# Intel<sup>®</sup> I/O Controller Hub 10 (ICH10) Family

## Specification Update

**December 2011**

Document Number: 319974-015

Figure 2-1. Intel® ICH10 Interface Signals Block Diagram

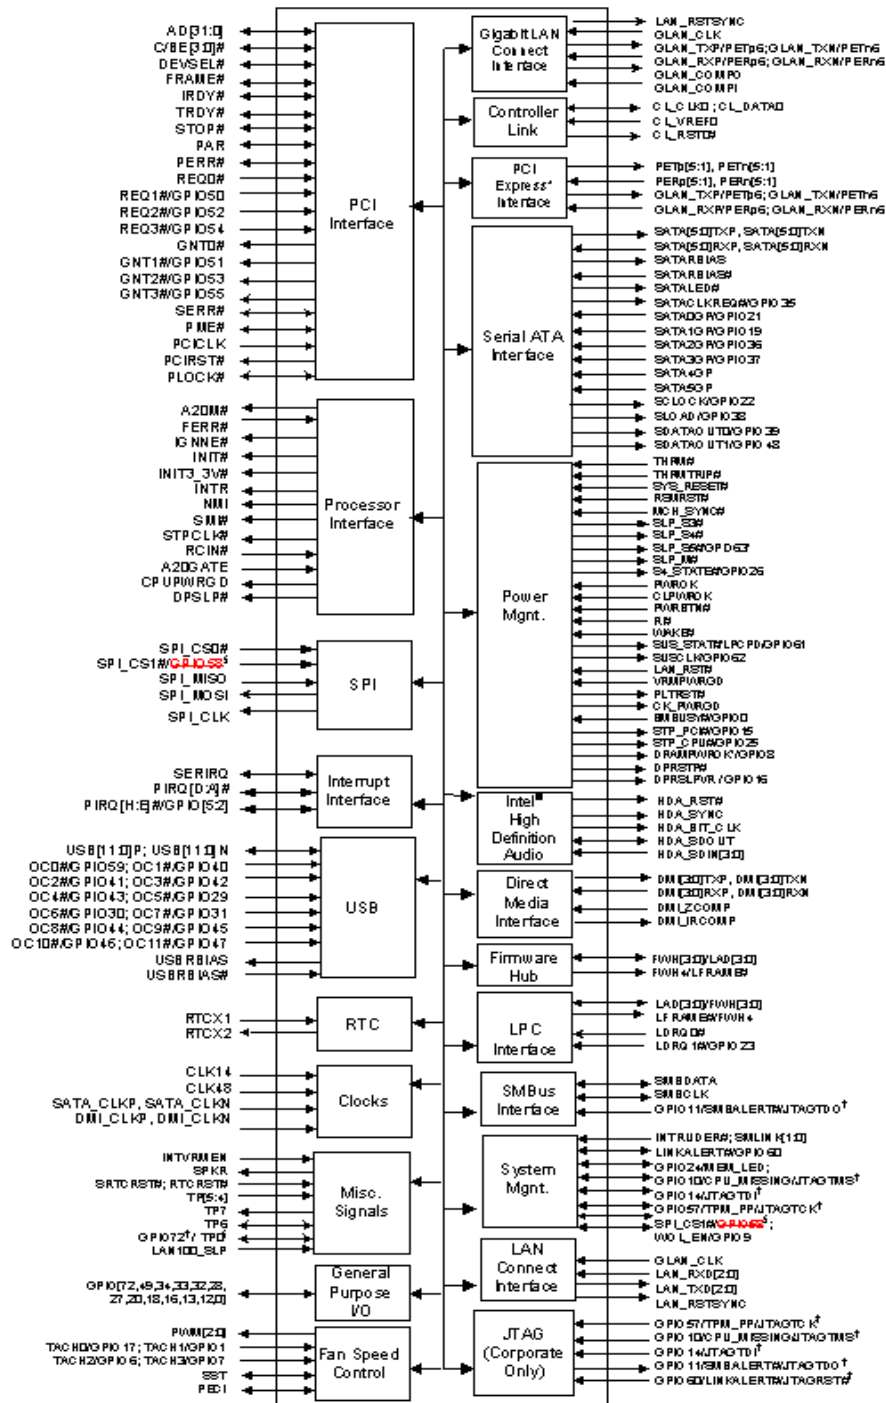
**9. Remove GPIO58 from Figure 2-1, Intel® ICH10 Interface Signals Block Diagram**

Update the following block diagram in Section 2, Signal Description, in the Datasheet.
